# Calero Trails Master Plan Site Tour Summary

Addendum November 2010

Santa Clara County Parks

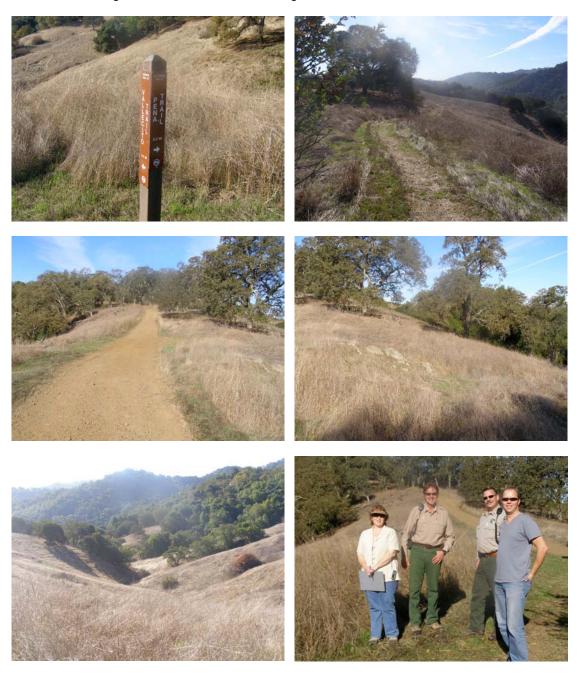
The Pena Trail is too steep in many places and as such is difficult to maintain each year. Consider relocating trail access, and converting the Pena Trail to an "unmaintained" access road for access to the water tank. A new trail could be located on the other side of the knoll which is to the north of the Pena Trail, and could provide access to the Vallecitos and Los Cerritos Trails.

If the Pena Trail is closed and a new access trail is created, provide a realigned Los Cerritos Trail connection to the Vallecitos Trail at this location. Also, consider an "upper Vallecitos" Trail alignment that stays on higher ground and may be dryer in Winter months, while the current Vallecitos Trail alignment that follows the drainage is desirable in the hot summer months.

With the closure of the Pena Trail, the Los Cerritos Trail would be re-aligned to connect with the Vallecitos Trail to the southeast, and would follow the lake edge contours to the west.

This is an important interpretive location and trail access needs to be maintained suitable for vehicles.

This area has potential for backcountry camping. The Chisnantuk Peak Trail is problematic for bike use and has one area that is difficult for quad turning. A trail realignment may be possible if the adjacent Open Space Preserve property could be considered for a joint trail that crosses jurisdictional boundaries.
